Re: Interpretation for SEA 01-S-028, Geshher Jewish Day School of Northern Virginia, Tax Map
56-4 ((1)) 19B and 56-4 ((3)) 1: SWM clearing

Re: SEA 01-S-028
Gesher Jewish Day School of Northern Virginia

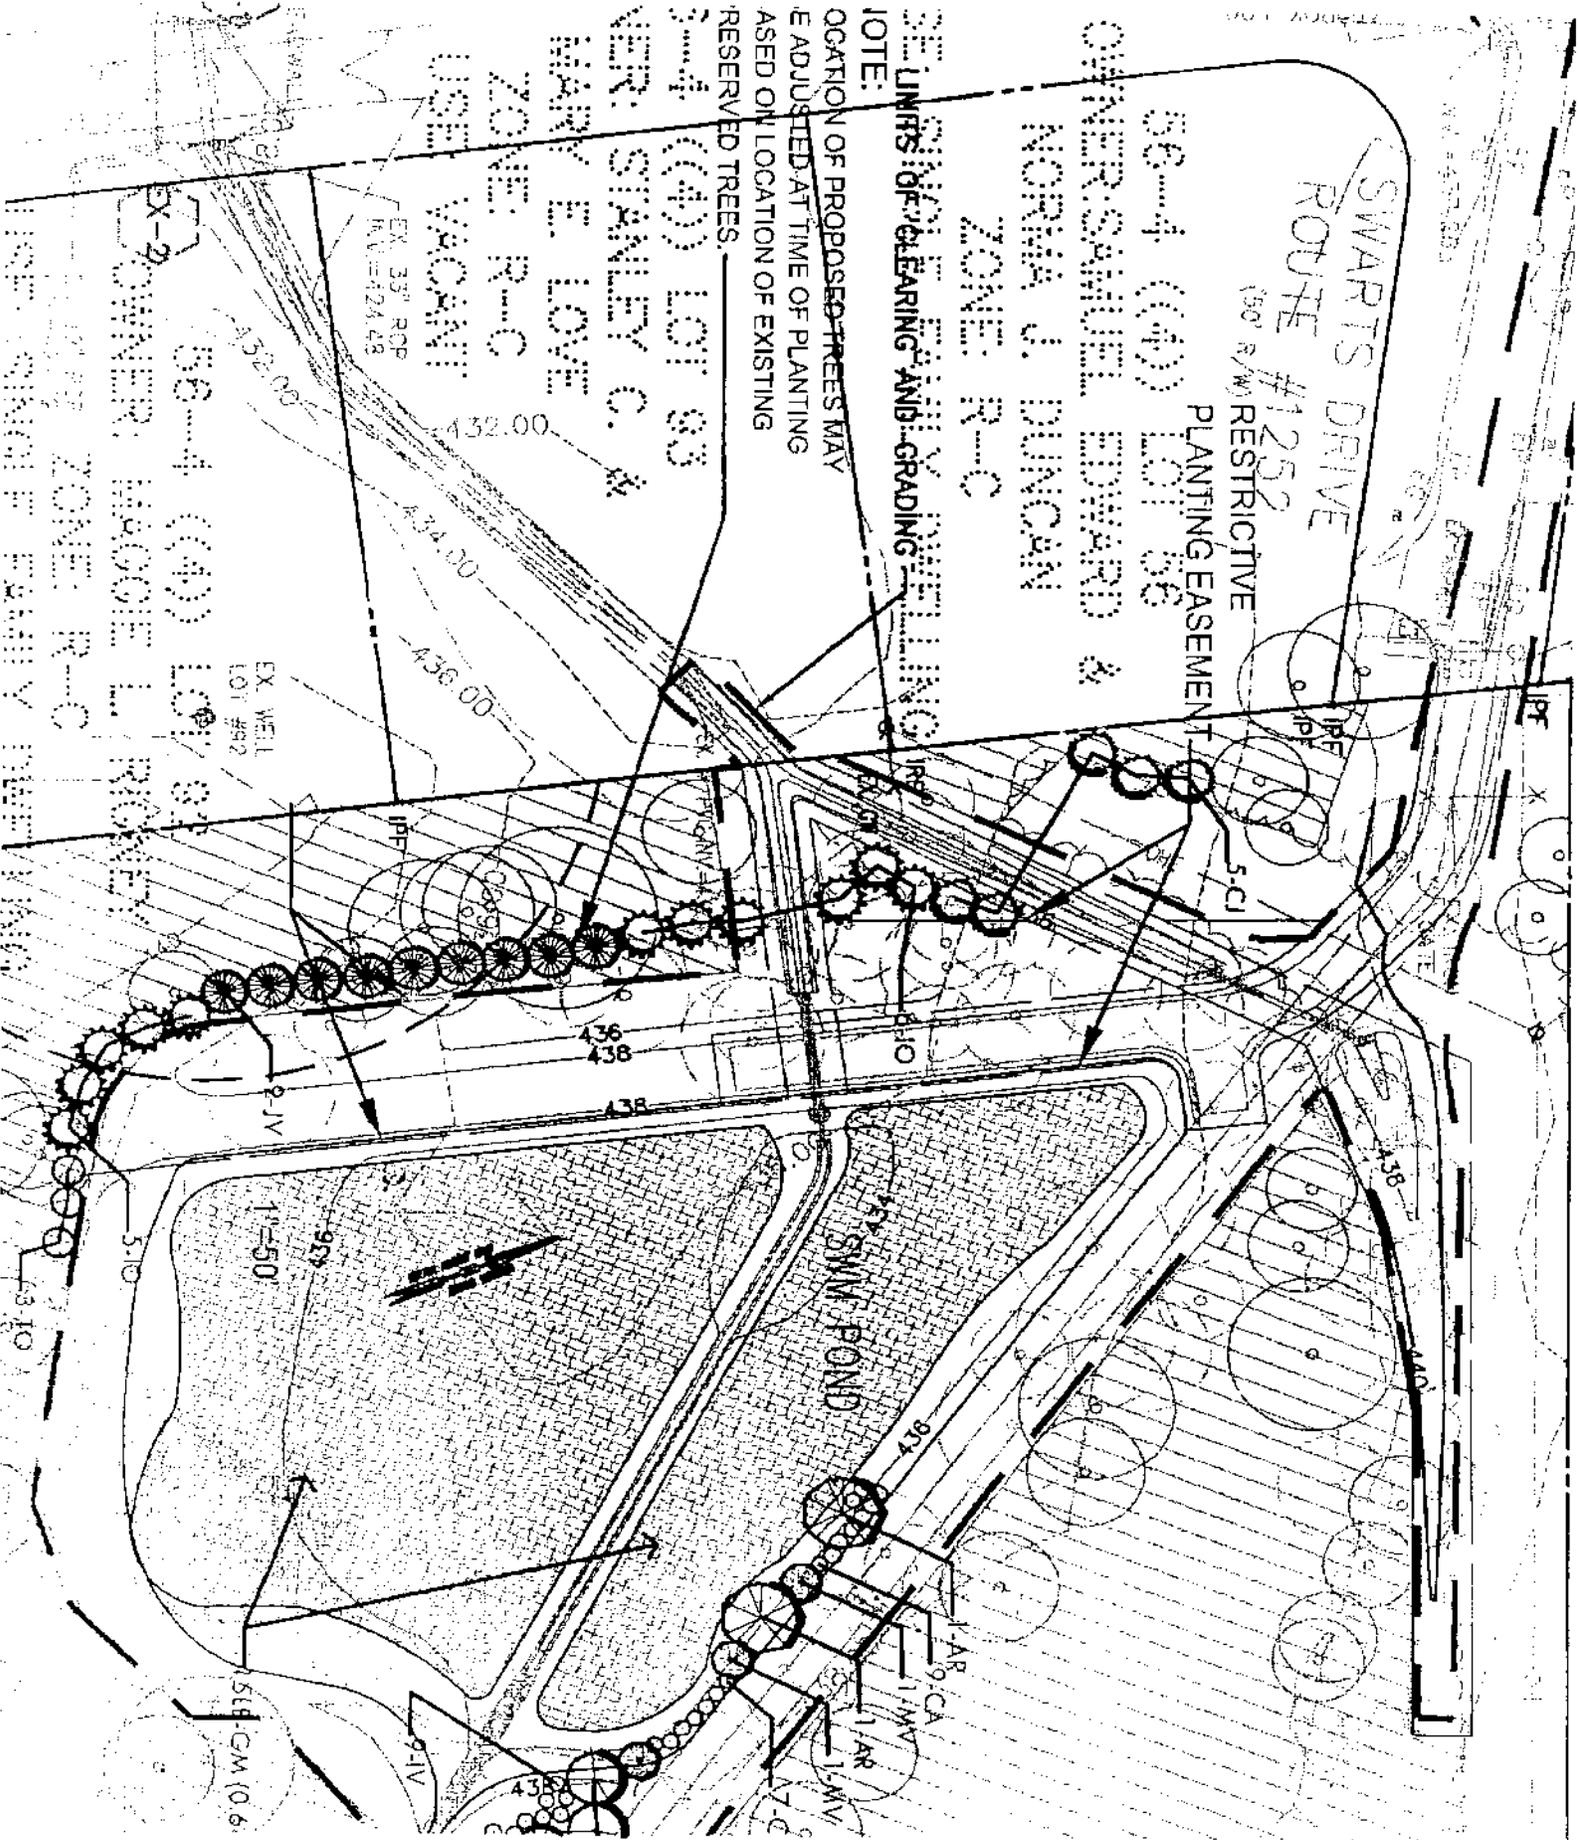
You have expressed concerns regarding the stormwater culvert pipe beneath the pond maintenance access road for the purpose of bypassing off-site runoff that is proposed in the northwest quadrant of the property. As we discussed, the area in which the pipe is located was not included in either the open space or undisturbed open space calculation for the approved special exception. In addition, the area of disturbance down stream of the culvert is quite small. It is approximately 2,160 square feet or less than .05 of an acre (too small to have been included in the open space calculations). Lastly, the area upstream of the culvert will have the appearance of a grassy swale, and the area down stream of the culvert will have a narrow (5ft. or less) concrete ditch for erosion control purposes once improvements are completed. Gesher is also willing to provide supplemental landscaping in this area to ensure that its appearance to the adjacent residential community to the west is consistent with that that was shown during the processing of the special exception application. I have attached an exhibit prepared by Patton, Harris, Rust and Associates to illustrate the landscaping that may be provided.

LOCATION OF PROPOSED TREES MAY BE ADJUSTED AT TIME OF PLANTING BASED ON LOCATION OF EXISTING RESERVED TREES.

LIMITS OF CLEARING AND GRADING ARE SHOWN BY DASHED LINE

Based on the above, it is my determination that the proposed modifications to the limits of clearing and grading to enlarge the SWM pond and install a culvert and drainage swale in the northwest quadrant of the site are in substantial conformance with the SEA plat and development conditions, as long as an adequate number of evergreen plantings are installed in the cleared area west of the dam embankment to provide year round screening of the SWM facility, as recommended by Urban Forest Management.
